PHILADELPHIA ELECTRIC COMPANY

SUBJECT: Limerick Generating Station, Units 1 and 2
Draft Fire Protection Section of the
Safety Evaluation Report

REFERENCE: Letter, A. Schwencer to E. G. Bauer, Jr.
dated April 19, 1983

DRAFT

LIMERICK GENERATING STATION UNITS 1 AND 2 FIRE PROTECTION EVALUATION REPORT	
AUXILIARY EQUIPMENT ROOM ARRANGEMENT	
FIGURE B-21	REV. 3, 04/83

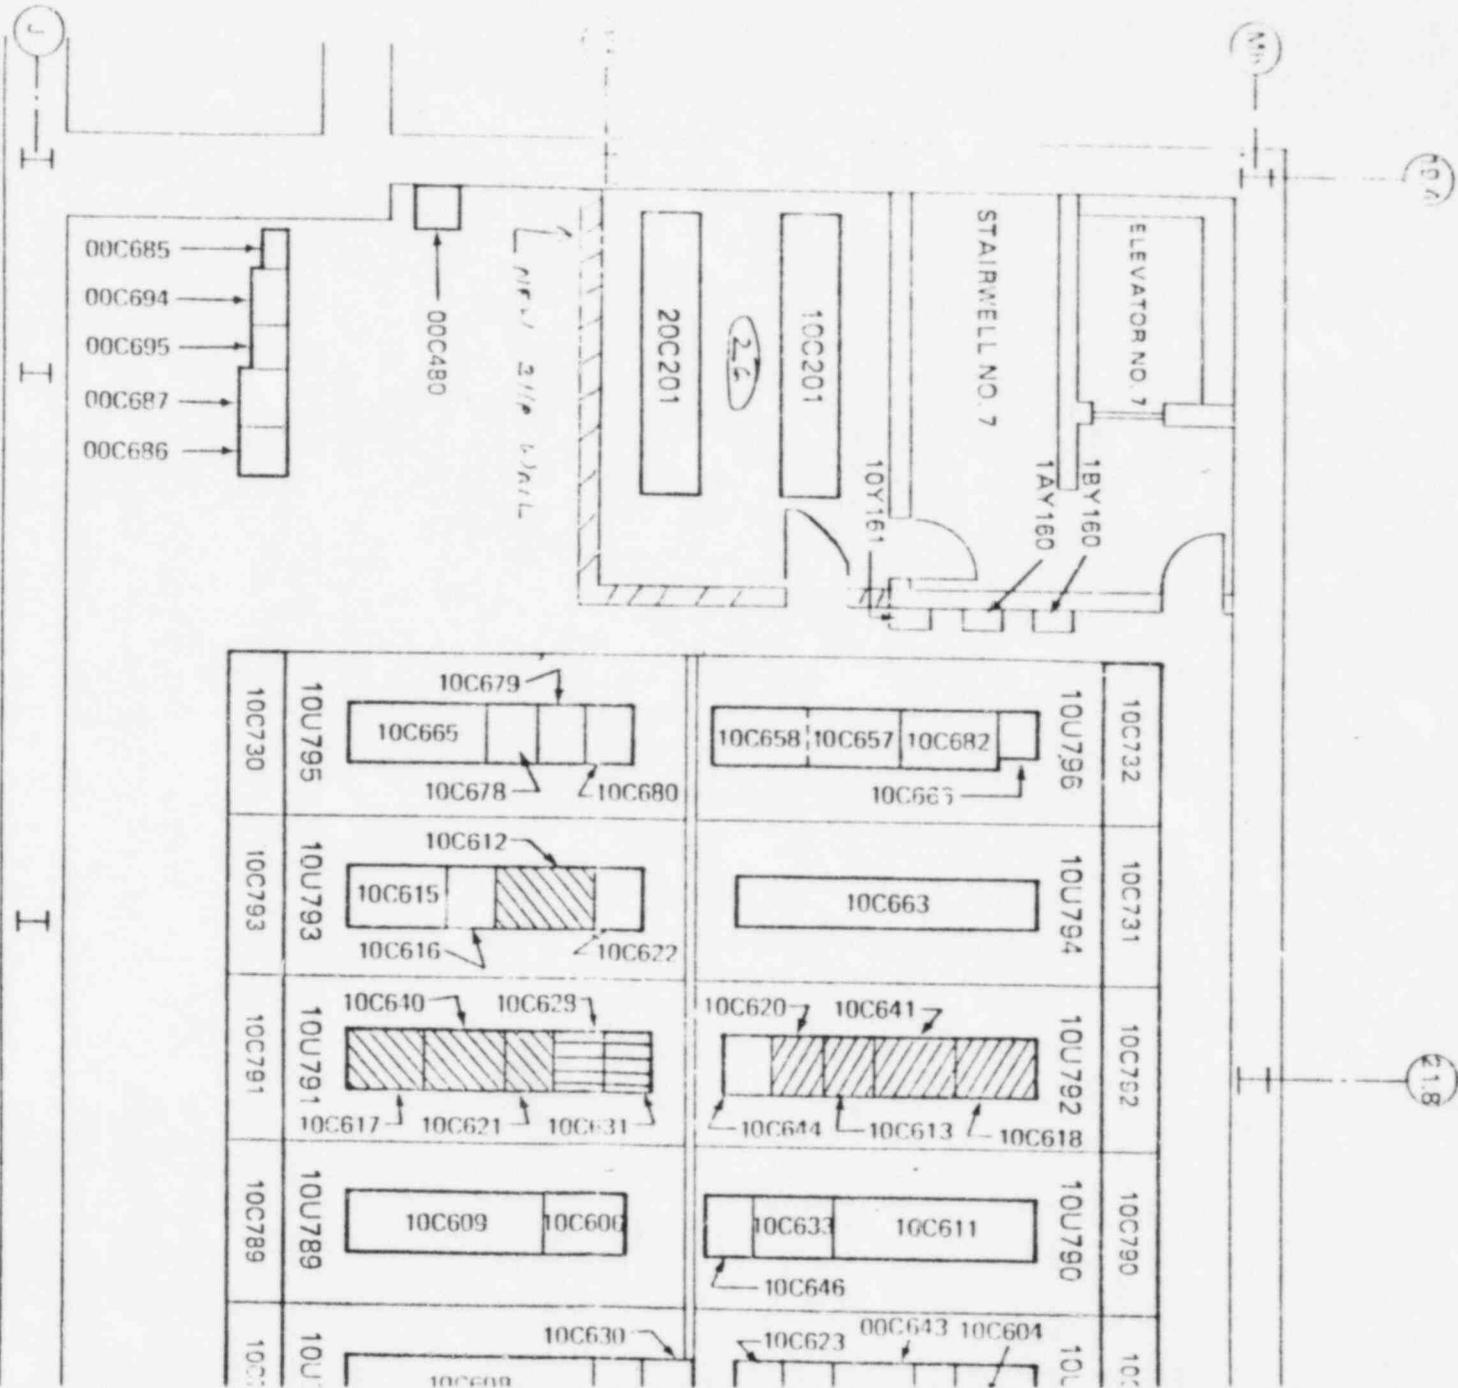
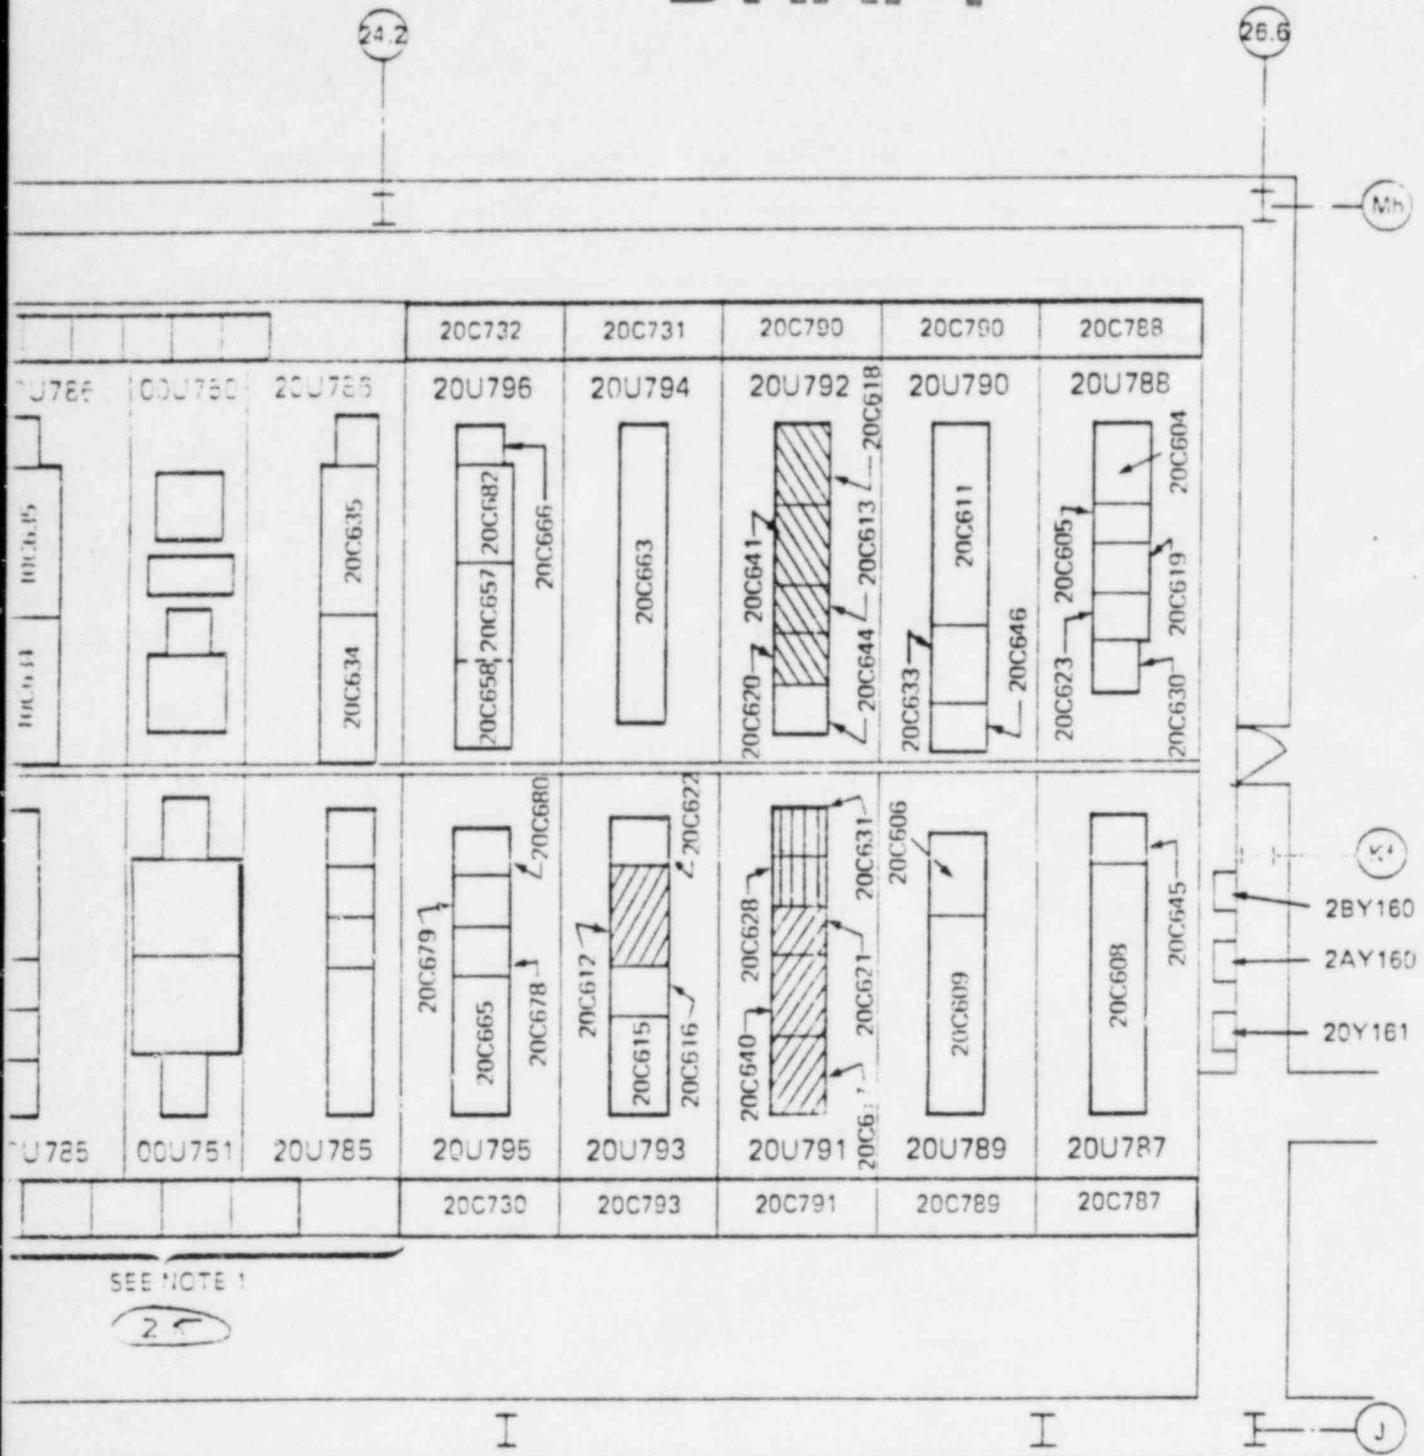
The applicant has not provided a description of the 2-hour rated fire barriers for the plant enclosed stairwells for us to independently verify compliance with our guidelines.

We require the applicant to provide details showing compliance with Section C.5.c of BTP CMEB 9.5-1.

Limerick will comply with the requirements of RTP CMEB 9.5-1, Section C.5.c, in Fire Area 25 and 26.

Drawings: FPER Figure B-21 (attached)

5 TYPICAL ONE HOUR RATED WALL & PLASTER CEILING DETAIL 3'-11.0"

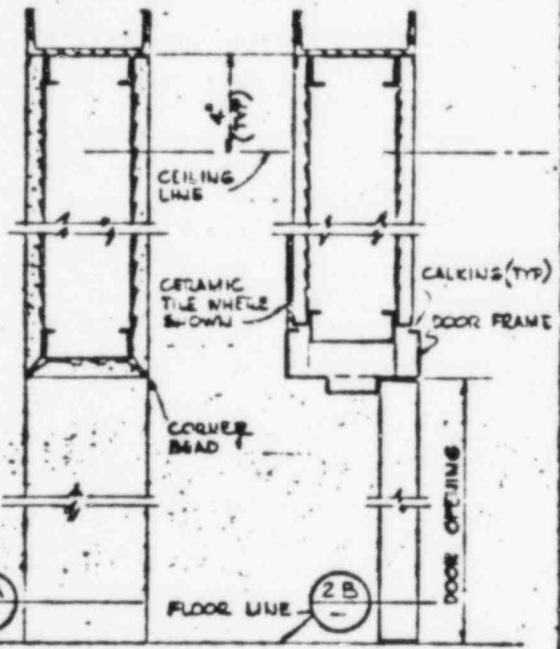
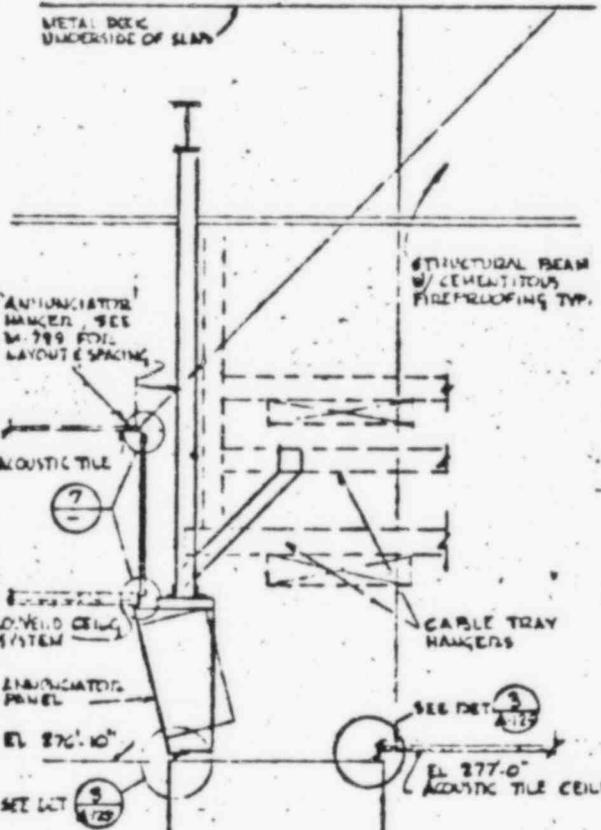
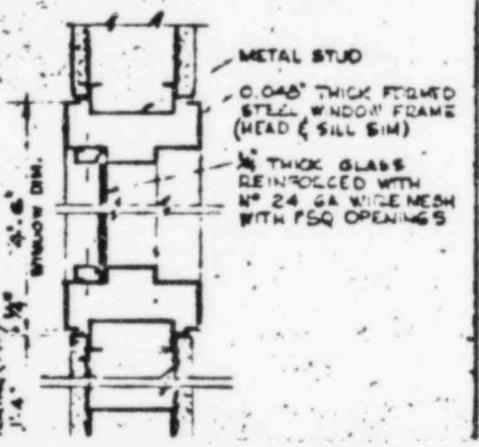
However, the applicant has not provided sufficient details of the control room complex for us to independently verify compliance with our guidelines.

We require the applicant to provide details showing compliance with Section C.7.b of BTP CMEB 9.5-1 of our guidelines.

Elevation 269'-0" of the control structure consists of the main control room and peripheral rooms, all contained within a 3-hr fire rated envelope, separating this portion of the structure from the rest of the plant.
